Department of Energy  
Office of Legacy Management

Subject: Revisions: Draft Long-Term Surveillance Plan for the Maybell West, Colorado,  
UMTRCA Title II Site

TOE APRON SECTION

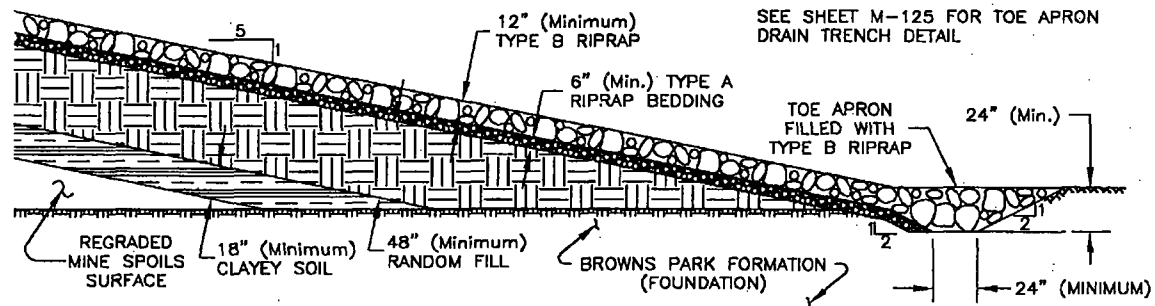
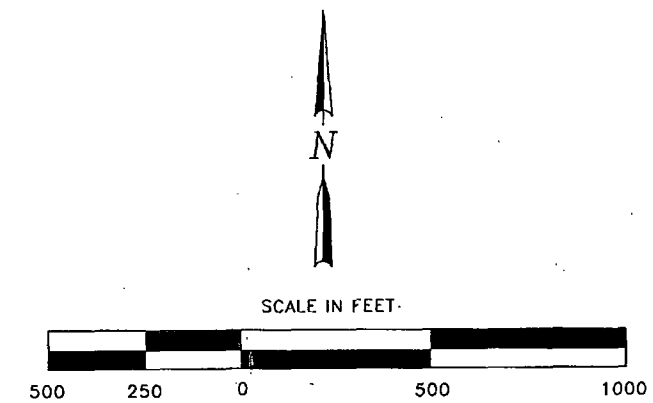
- Figure 2-6 (page 2-11) *Typical Cover Cross-Section, Maybell West, Colorado, Disposal Cell*: This figure was revised to include: the apron at the toe of the disposal cell.

U.S. DEPARTMENT OF ENERGY GRAND JUNCTION, COLORADO	Work Performed by S.M. Stoller Corporation Under DOE Contract No. DE-AC01-02GJ79491
DISPOSAL SITE MAP MAYBELL WEST, COLORADO	
DATE PREPARED: AUGUST 7, 2007	FILENAME: S0331600

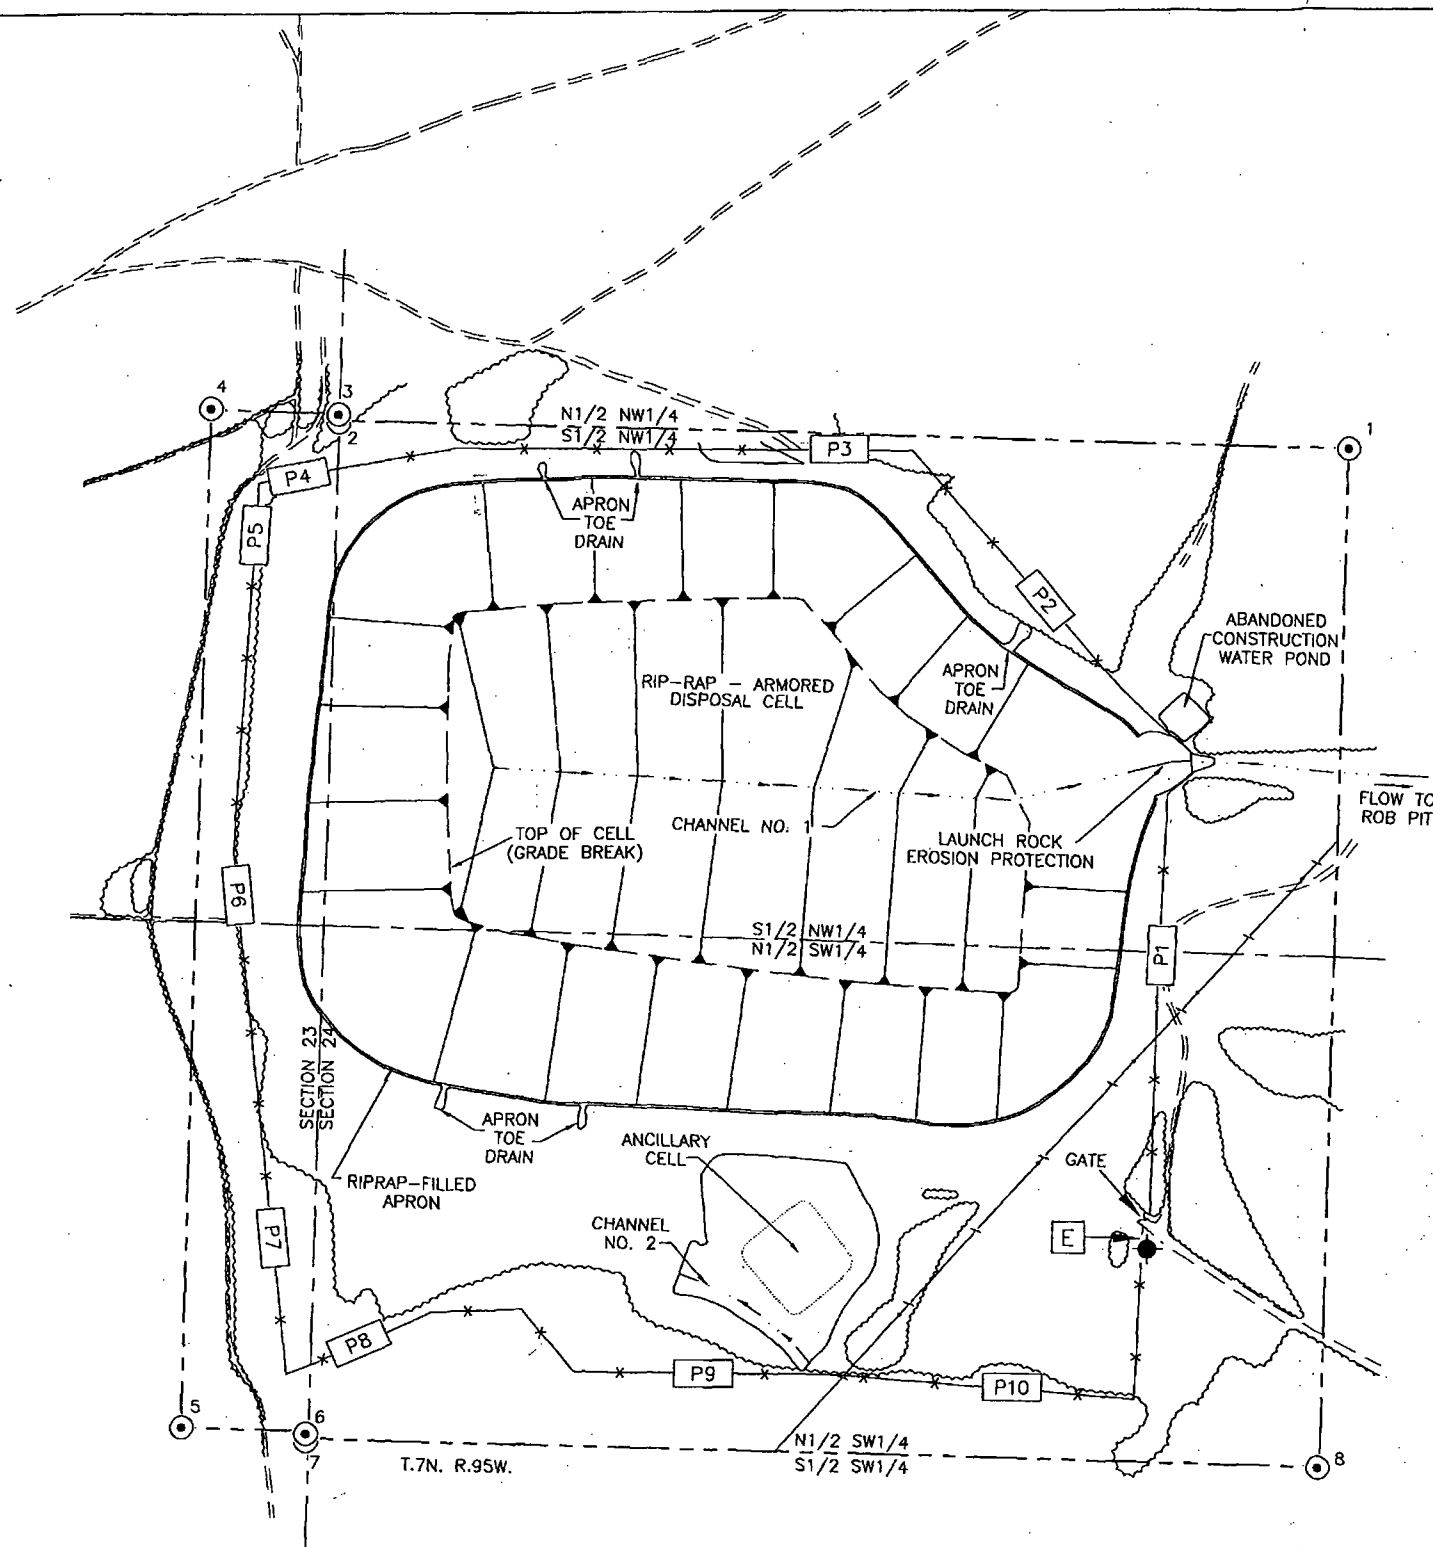
- Figure 2-2 (page 2-5) *Maybell West, Colorado, Disposal Site Map*: This figure was revised to include: the apron at the toe of the disposal cell; a grade break to distinguish the top of the cell from the side slopes; flow lines and flow direction in Channel No. 1 on the cell top; disposal cell slope direction lines; a correction to the scale; and perimeter warning signs locations.
